July 16, 2019

Re: Preliminary Plat for Lavitt Manor II—Two Lot Subdivision: 7525 N. Ironwood Drive

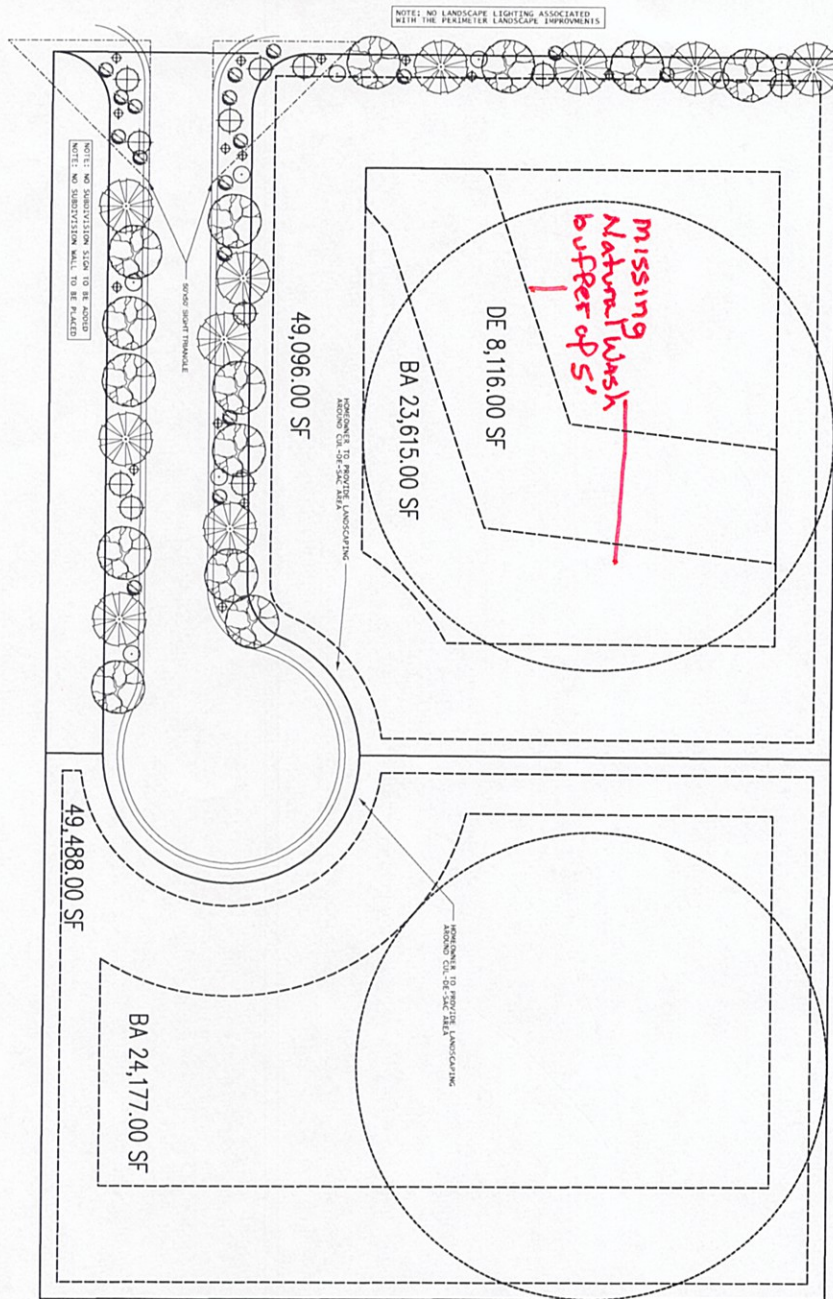
A close review of the proposed Preliminary Plat and the Paving Grading Drainage shows the five cross sections of the wash **are not** equally spaced **and not** across the entire wash (*see exhibits*); moreover, the information contained within those points selected warrant the Commission asking for further information. Point C3-6 appears in the 20 foot landscape area of the Preliminary Plat and appears to be approximately 8 feet from the beginning of the wash on the subdivision property. In contrast, point C3-10 appears to be approximately 30 feet from the end of the wash where it enters the easement created by the large Natural wash. The Storm Drainage Design Manual and the Town Code require equally spaced cross sections across the property—which the drainage cross sections provided are not. The reason for the non-equally spaced cross section points will become evident when viewed together and discussed below.

When the five cross sections provided in the Preliminary Drainage Report are analyzed it seems that Point C3-10 was merely taken in a position to ensure the smaller wash on the property was not defined as a Natural Wash or a Watercourse. First, look at the cross section points provided:

Plat Points	Elevation Pt. 1	Elevation Pt. 2	Depth of Wash	Width of Wash
C3-6	1373.0	1371.6	1.2 feet	5.70 feet
C3-7	1373.0	1370.0	3.0 feet	6.20 feet
C3-8	1372.0	1370.0	2.0 feet	7.50 feet
C3-9	1371.0	1369.3	1.7 feet	5.24 feet
C3-10	1370.3	1368.35	1.95 feet	4.36 feet

Two of the five points meet the requirements to deem the smaller wash a “Natural Wash.” However, point C3-10 is the only point that expands to the hundredth decimal position and is a mere ½ inch away from the 2.0 foot mark to make the wash a Natural Wash with an easement needing to be given to the Town to protect the wash. More importantly, look at point C3-10 on the Paving Grading Drainage Plat—point C3-10 is approximately 30 feet from where it exits into the large Natural Wash with no cross sections taken in the area (recall point C3-6 was taken only about 8 feet from the end of the wash on the south side of the property) *See exhibits*.

The reason the final cross section point C3-10 is not closer to the larger wash is because the closer the smaller wash gets to the entry to the major wash, the more the elevation drops (between 1368 and 1366 feet) and the wider the wash gets. Necessarily, if the cross section points

were taken equally spaced across the entire smaller drainage wash as required by the Town Code and Storm Drainage Design Manual (or an additional point is taken between point C3-10 and the exit of the smaller wash into the major wash), there would assuredly be at least three points that exceed a depth of 2.0 feet and width of 5.0 feet—making the smaller wash a Natural Wash or Watercourse. At a minimum, the Commission needs to investigate this issue given the Code requirement of equally spaced cross sections **across the property** was not followed completely and there appears to be an attempt to influence the Commission to believe the smaller wash is not a Natural Wash or Watercourse.

With the new Natural Wash and landscape buffer zone required adjacent to both Natural Washes, Lot 1 of the proposed Subdivision will be trifurcated into three separate land masses (*see exhibit*) making it difficult, if not impossible, to provide a satisfactory and desirable building site as is required to approve a new Subdivision under Paradise Valley Town Code 6-3-5(A). Once an appropriate Plat map is presented to the Commission reflecting the Natural Washes and buffer zones, it will become readily apparent the building site will not be satisfactory or desirable. Indeed, it would seem that the prior developer recognized the importance of preserving the Natural Washes and the difficulty in developing around the washes. Thus, only a single lot was developed—rather than two lots.

Does not show required Landscape Buffer here or on plat 3-6(3) Storm Drainage Design Manual

Did not provide Landscape Buffer or Equivalently Spaced Cross Section Across Entire Wash

Drainage 3-6(2)
 DRAINAGE 3-6(3)
 PV CODE 5-10-7
 PV CODE 6-3-8
